Office Action Summary	Application No. 10/691,591	Applicant(s) PETERSON, GARY	
	Examiner LEAH S. LOVELL	Art Unit 2885

DETAILED ACTION

4. Claims 7-9, 11 and 13 are rejected under 35 U.S.C. 102(b) as being anticipated by Brown (US 6,016,101).

FIGURE A: Figure 3 of Brown that has been modified to indicate different portions of the light. A magnified view of the groove has been added to indicate the groove and its floor.

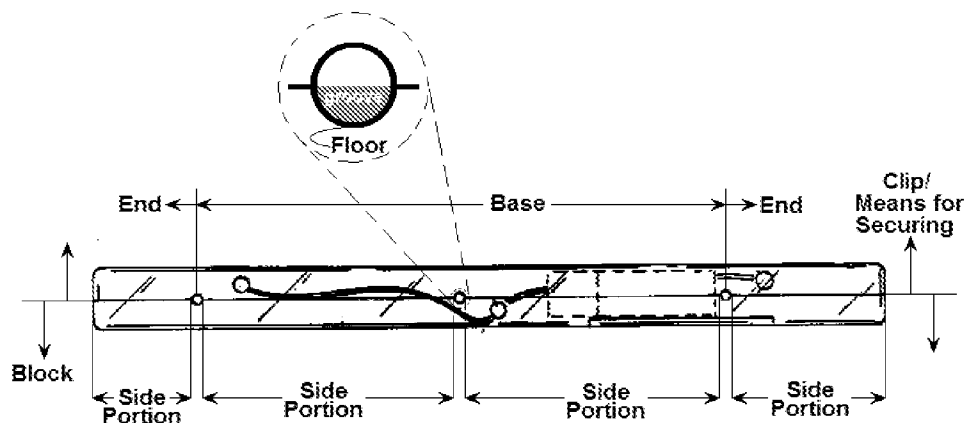
said block [20] having two side portions [see figure A provided below], and

said block having a groove [column 3, lines 59-61] between said side portions [see figure A provided below], and

said groove having a floor [see figure A provided below], and

In regard to claim 7, Brown discloses said means [26] on each of said two ends, which engage said block, engage said floor of said block [the hardware 26 which engages the block also engages the floor of the groove of the block since it presses the spoke against the floor of the groove].

In regard to claim 8, Brown discloses the light in combination with a wheel [16], and said wheel [16] has a plurality of spokes [14], and said block [20] is positioned on one side of said spokes [figure 3; figure A above], and said clip [18] is positioned on an opposite side of said spokes [figure 3; figure A above].

said block [20] having two side portions [see figure A provided above], and

said block having a groove [column 3, lines 59-61] between said side portions [see figure A provided above], and

said groove having a floor [see figure A provided above], and

wherein said means [18, 26] for securing said block to a bike
comprises a clip [18], said clip having two ends and a base [indicated in figure A above], each of said two ends having means [26] for engaging
said block with the spoke in the groove [figures 2 and 3]; and
